Administrative Amendment Approval of a Site Plan for a multi-family apartments project with 254 dwelling units, deviating from the original DRB-approved site plan consisting of an apartments project with 256 dwelling units.

**RE: ADMINISTRATIVE AMENDMENT FOR TRANSPORT APARTMENTS SITE PLAN
2900 TRANSPORT ST SE
LOTS 1-A AND 2-A-1 BLOCK 2 SUNPORT PARK
ZONE ATLAS PAGE M-15-Z**

Tierra West, LLC, on behalf of The Opus Group, requests approval for an Administrative Amendment to the Site Plan for Building Permit for the above referenced project. The project is located at 2900 Transport St SE, Albuquerque, NM 87106.

SITE PLAN

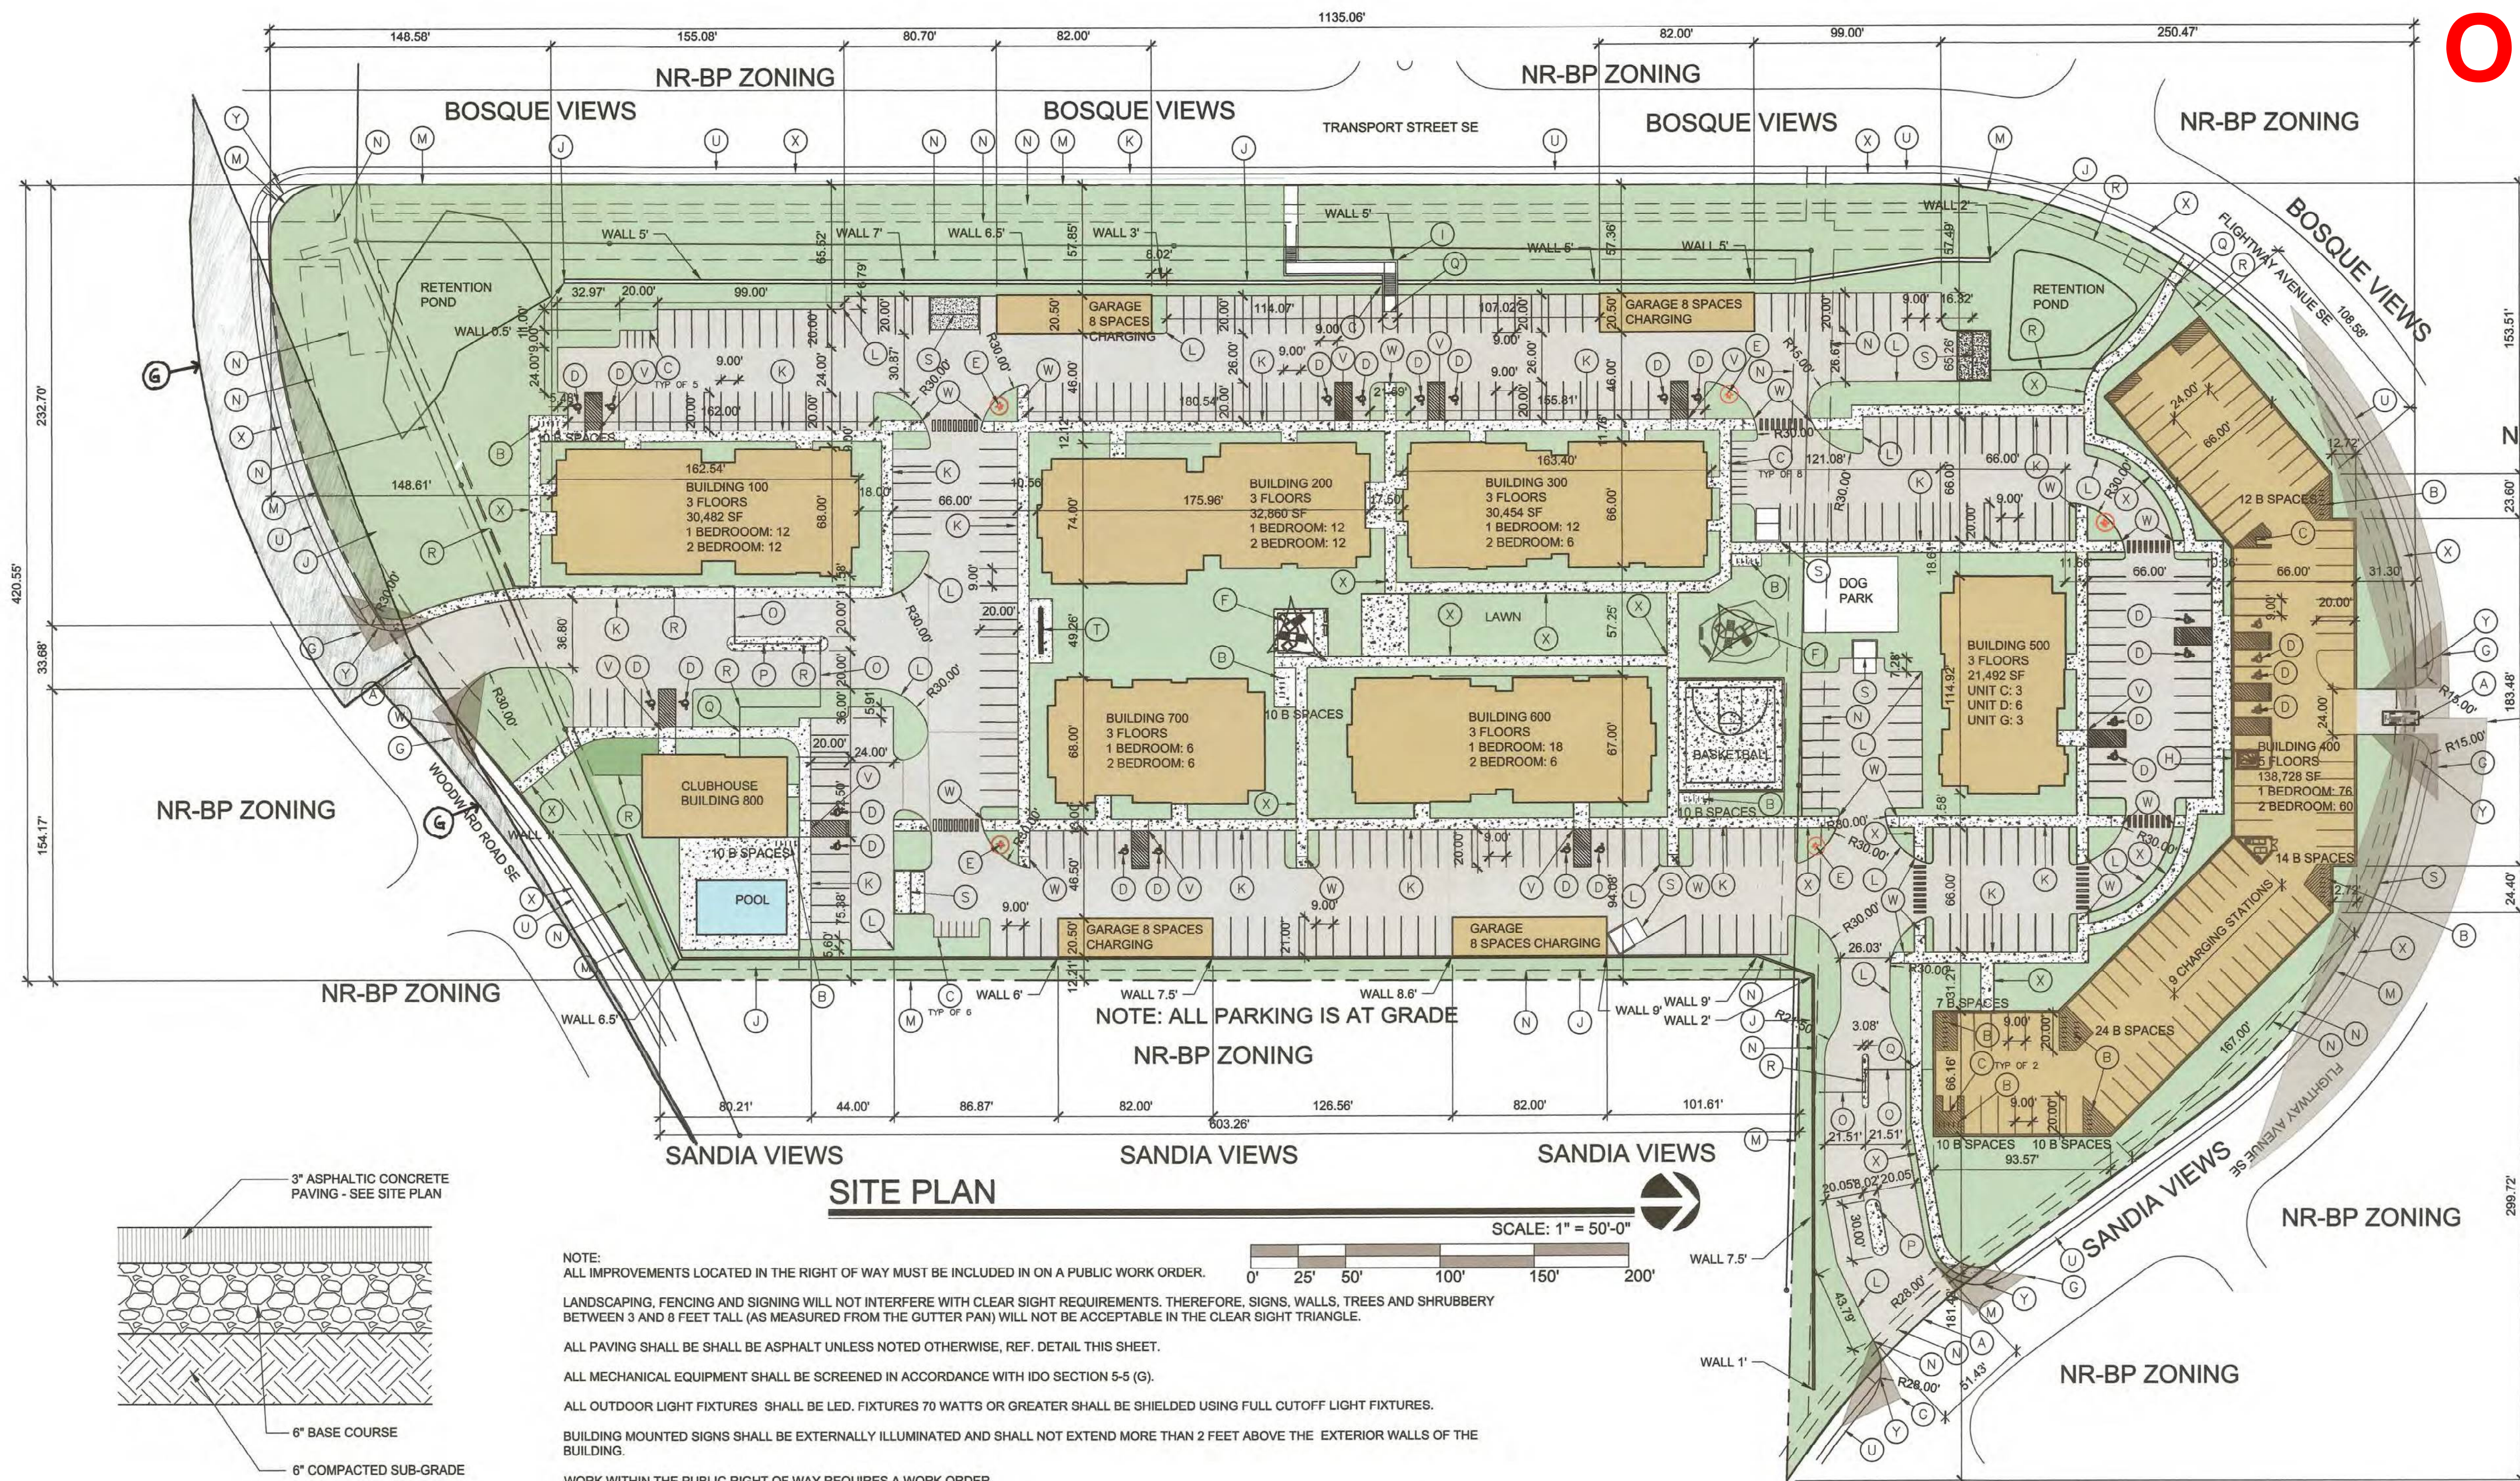
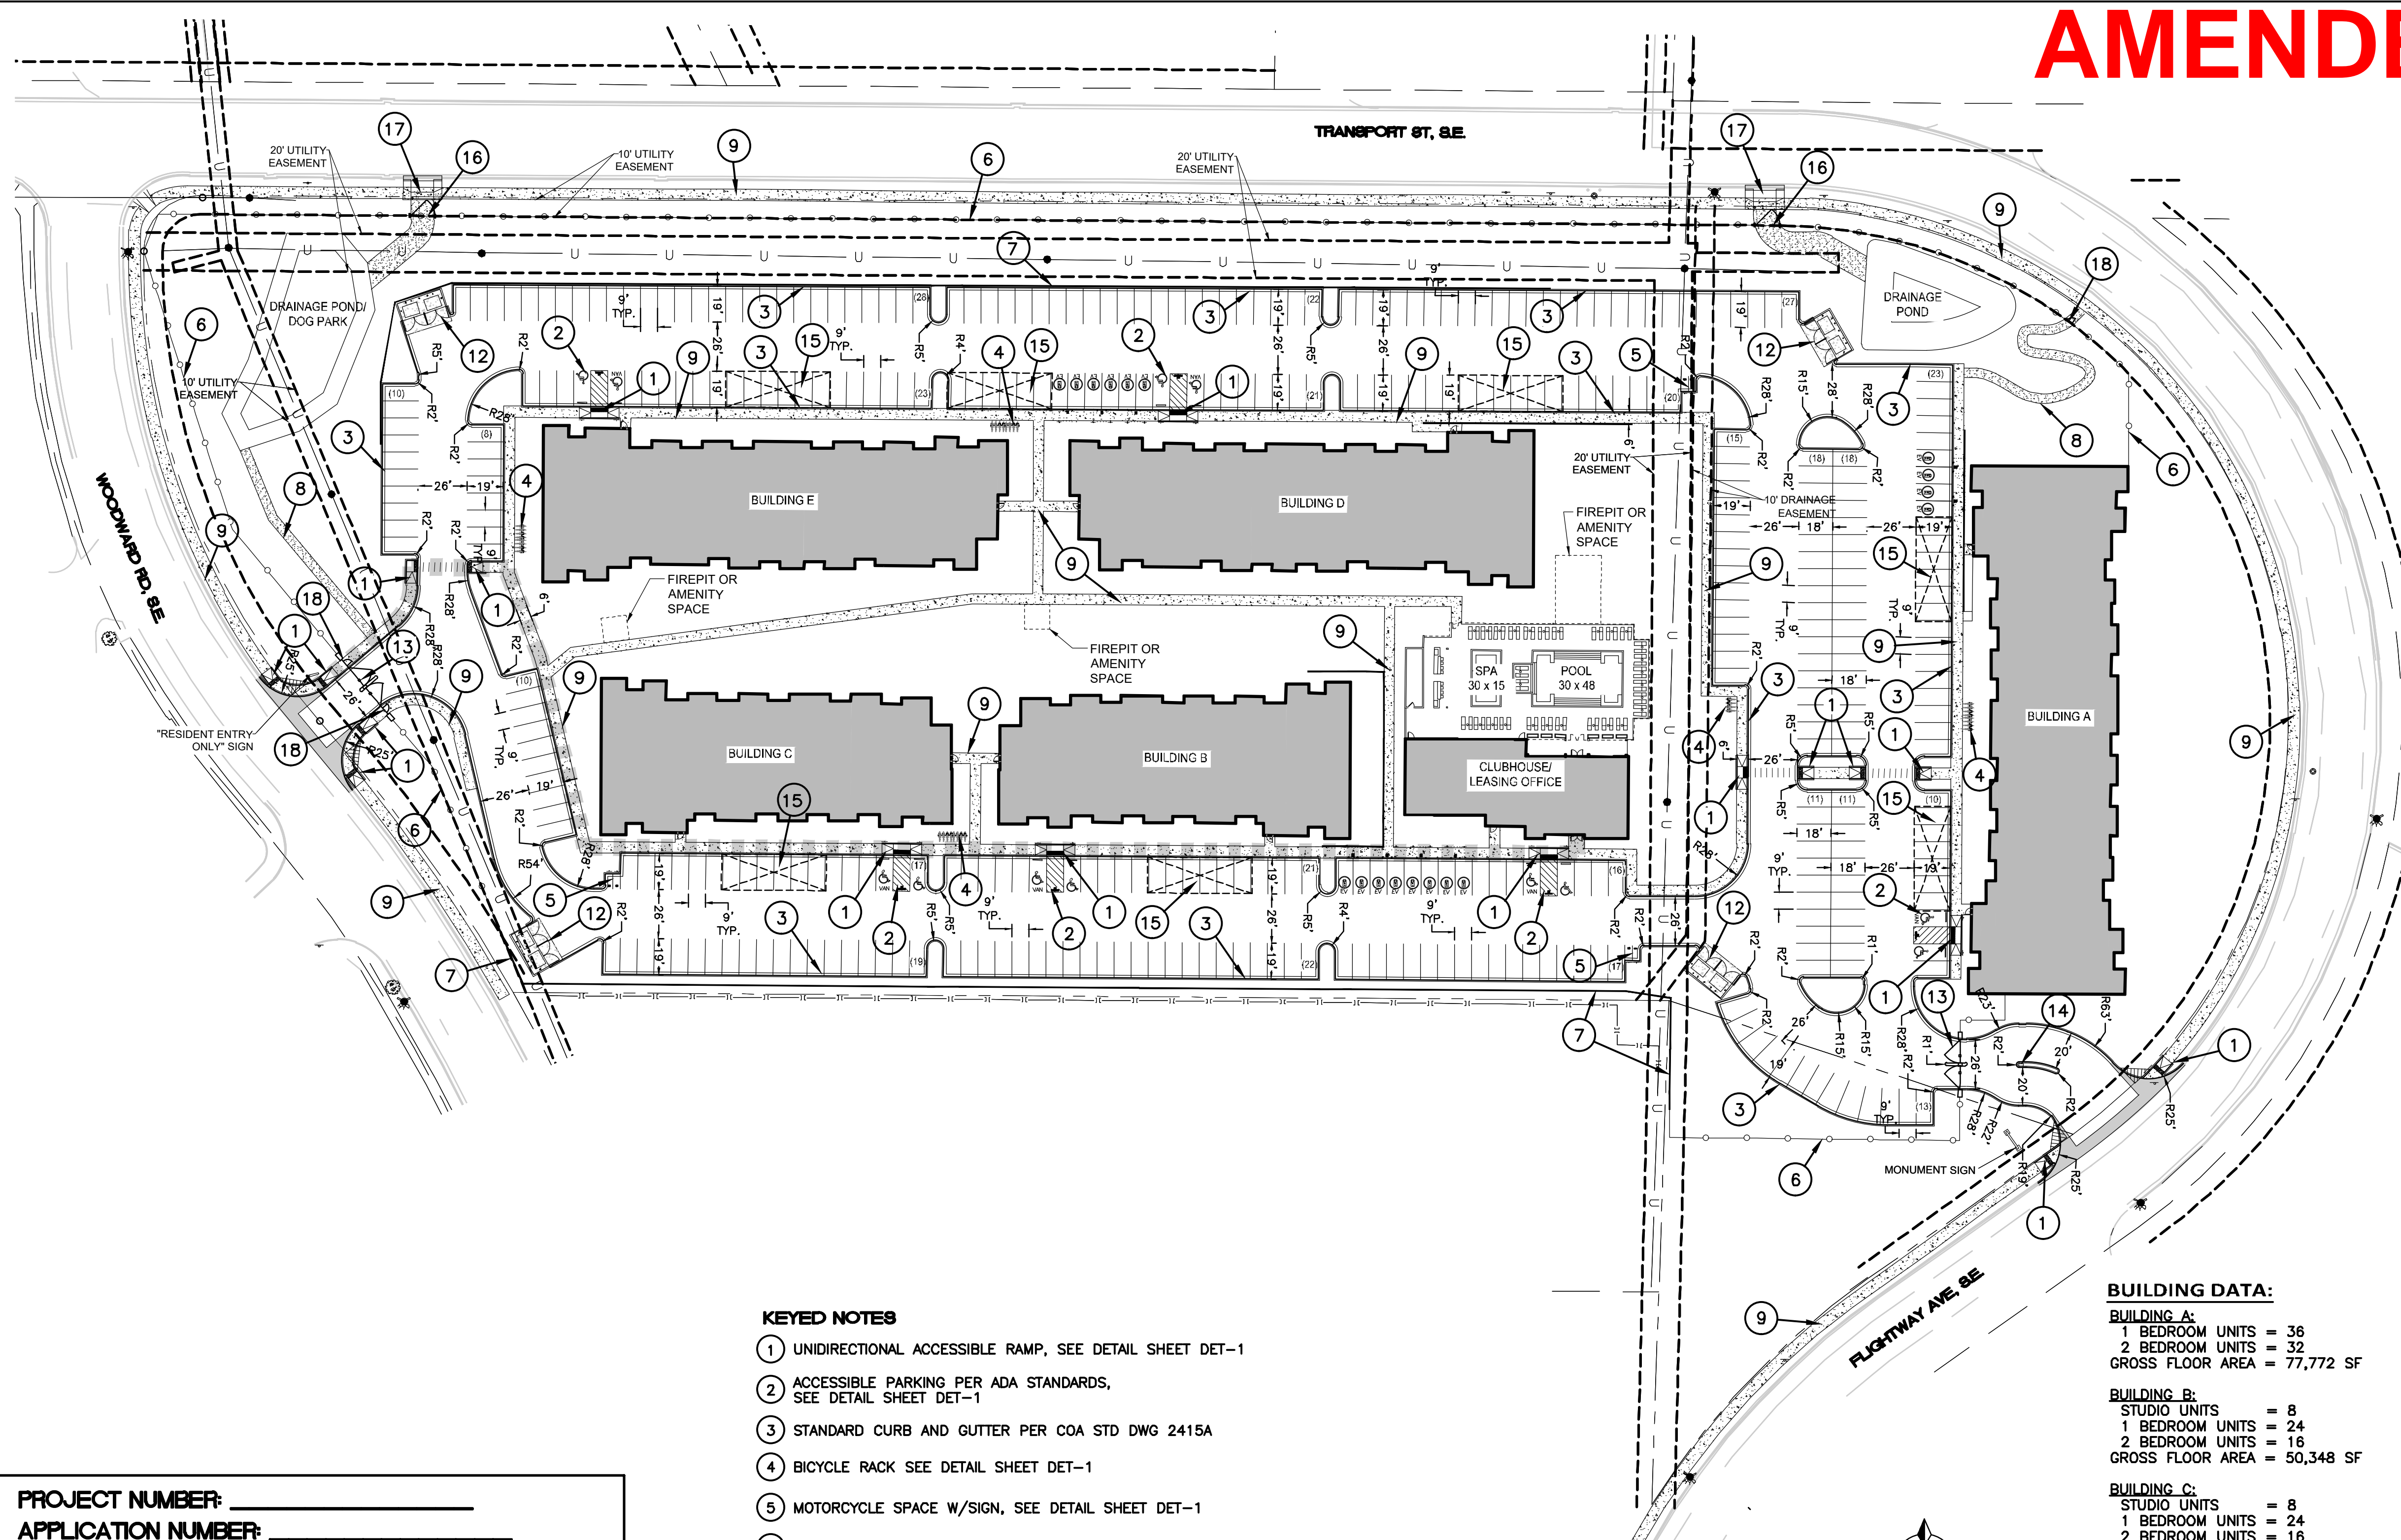
This Site Plan was Approved by the Development Review Board for a multi-family development consisting of 256 units within 7 residential buildings plus a clubhouse with a pool amenity area. The amendment request is to adjust the site for the unit count and building quantity and orientations. The proposed site plan will consist of 254 units within 4 residential buildings plus a clubhouse with pool amenity area. The change will reduce the approved site plan's unit count by 2, which is a decrease of 0.8% in the unit count. The traffic circulation, grading, drainage, and utility concepts that were approved by the DRB will remain the same for this amended site plan.

RESPONSE: The initial total building gross floor area is 310,000 square feet. The amended site plan has a total gross floor area of 281,087 square feet which is a 9.3% change. The number of dwelling units is being reduced by 2, which is a less than 1% change. All other design standards listed in Table 6-4-4 are remaining the same.

RESPONSE: This request does not decrease the total amount of open space. The amendment increases the amount of open space from 104,771 square feet to 207,690 square feet.

RESPONSE: This amendment increases the amount of total landscaping from the original site plan which furthers the amount of screening and buffering requirements.
